Relay rack moves

C.Y. Tan
02 Mar 2018

BPM RACK
PERIODS 06-08

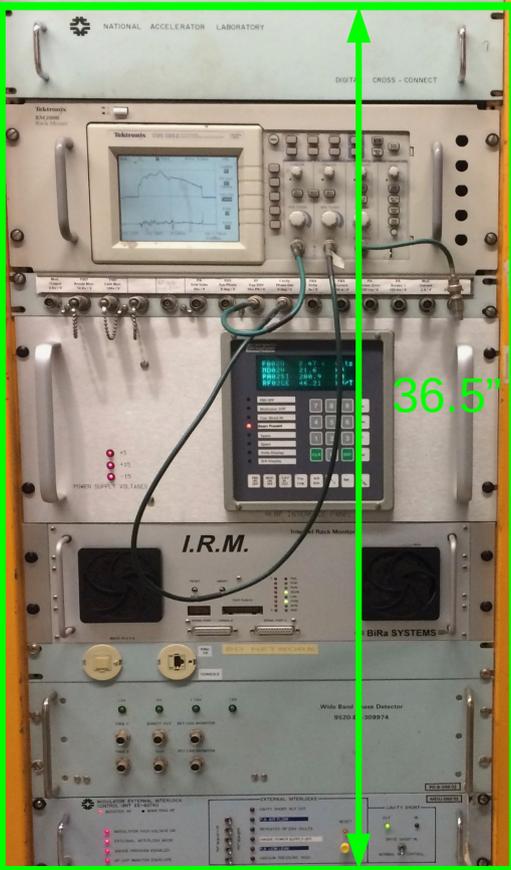
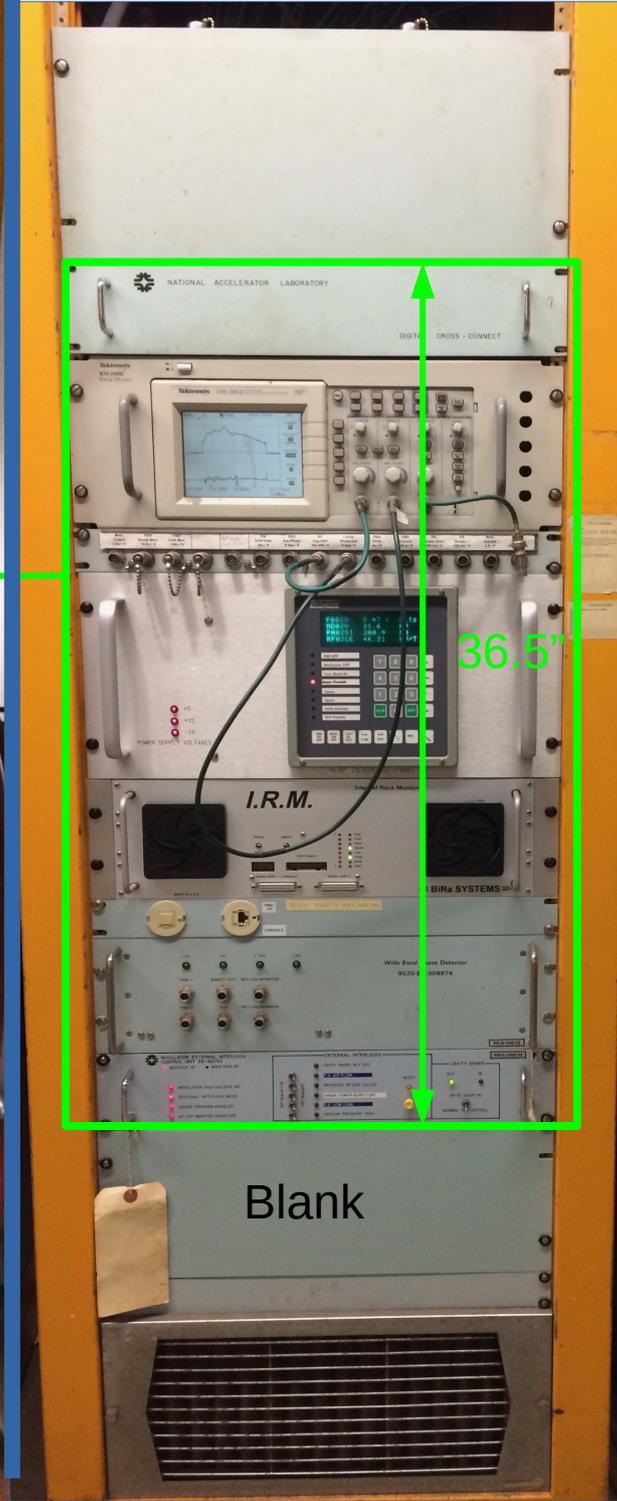
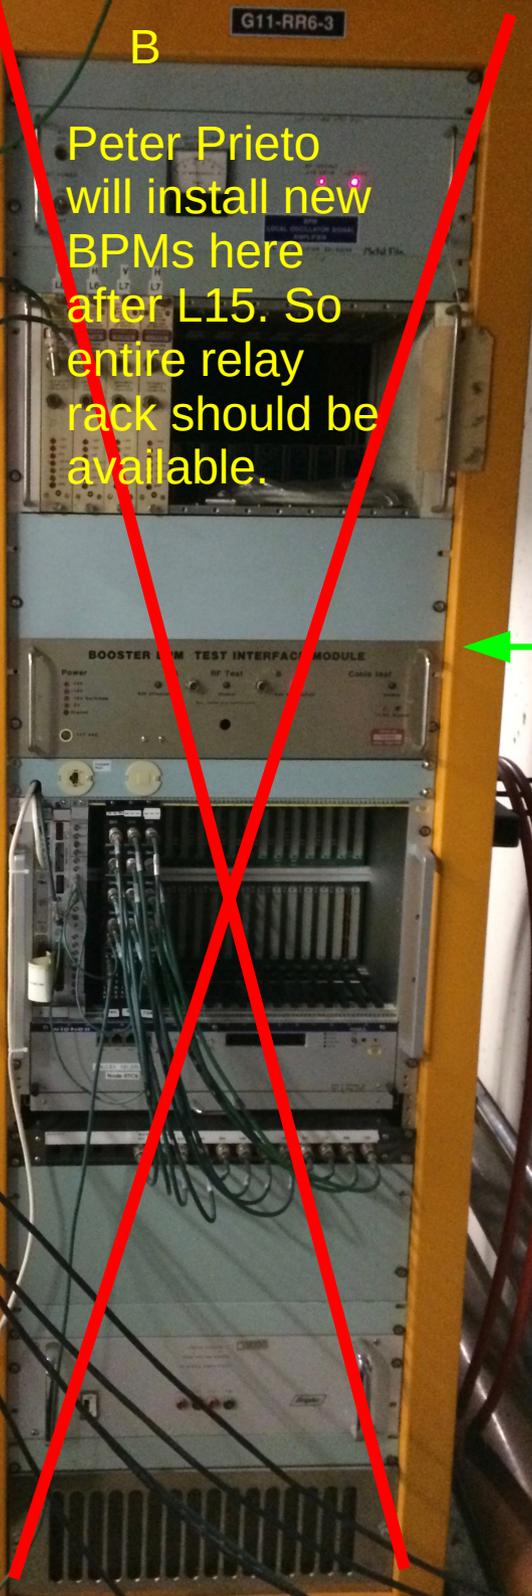
Peter Prieto will install new BPMs here after L15. So entire relay rack should be available.

Location of SSA

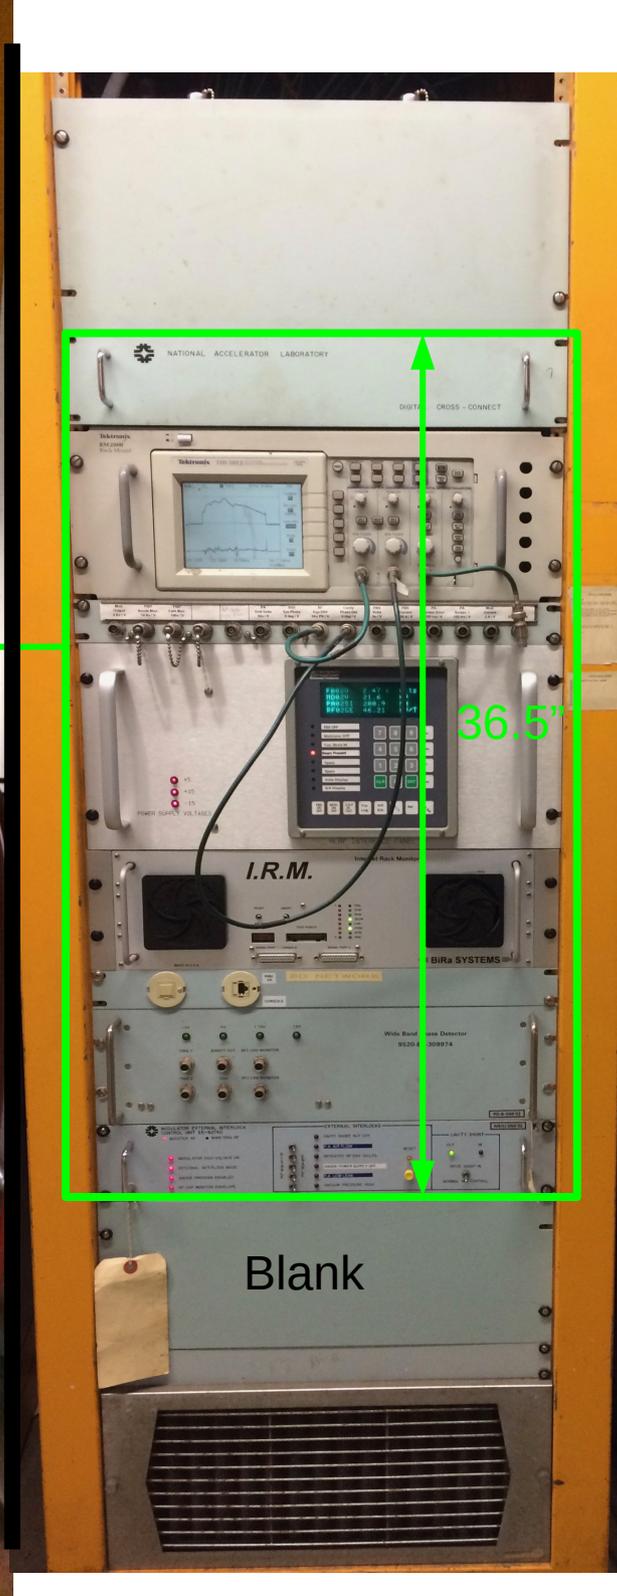
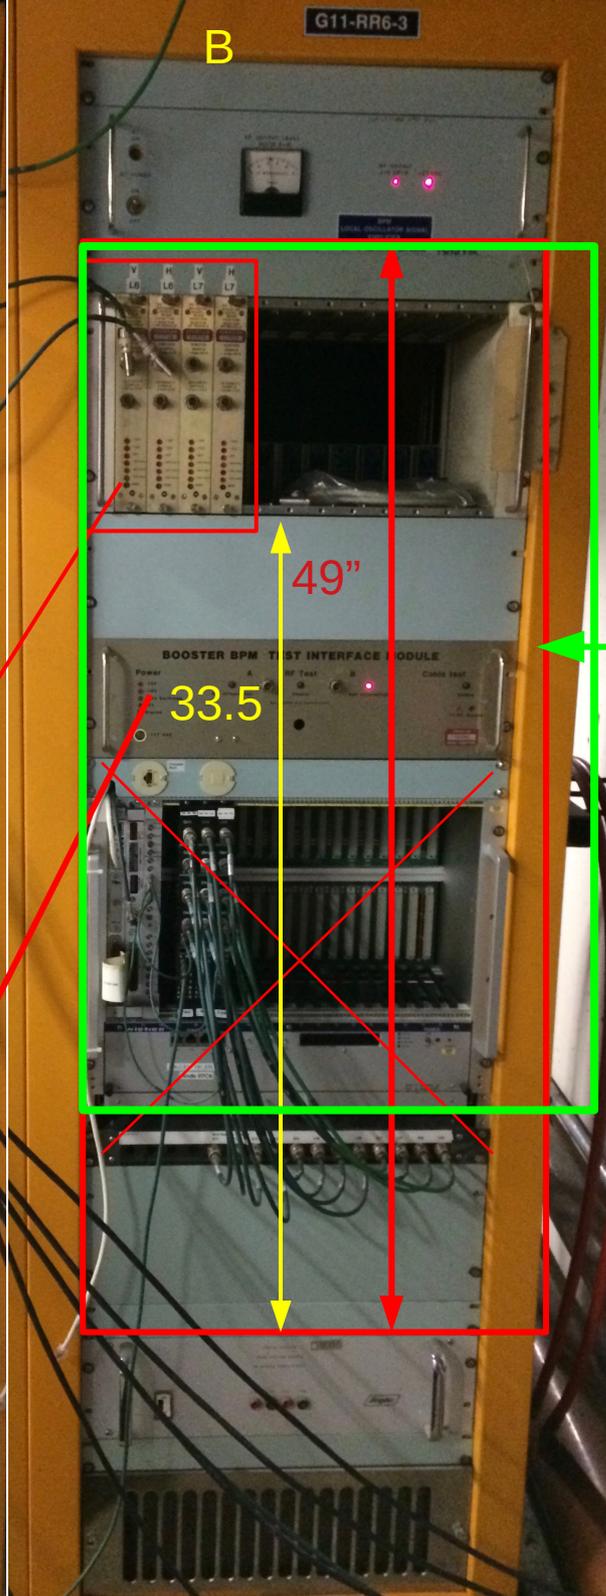
The SSA relay rack will go where the yellow fire cabinet is.

How will the hoses be installed?
